Ortho Clinical Diagnostics	<p style="color: red; margin: 0;">URGENT FIELD SAFETY NOTICE</p> <p style="margin: 0;">Potential Sample Metering Anomaly on VITROS® Systems using Software Version 3.2.2 and Below</p> <p style="color: red; margin: 0;">Immediate Action Required</p>
----------------------------	---

Date April x, 2016

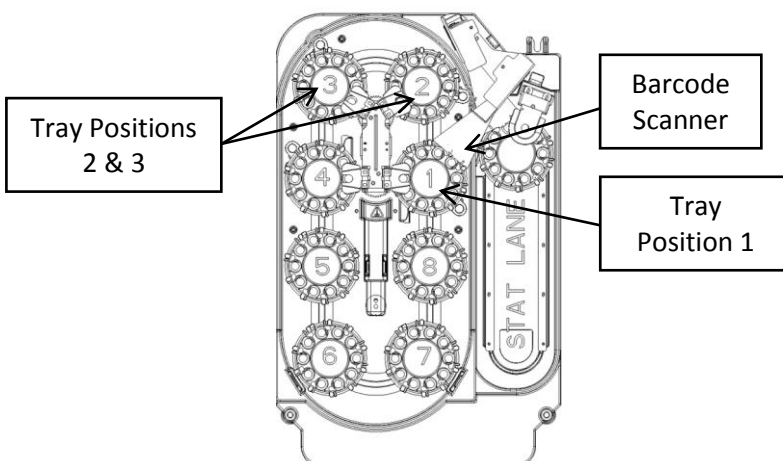
4. How can I determine tray positions in the Sample Supply?

The affected positions located in the Routine Lane of the Sample Supply as shown below:
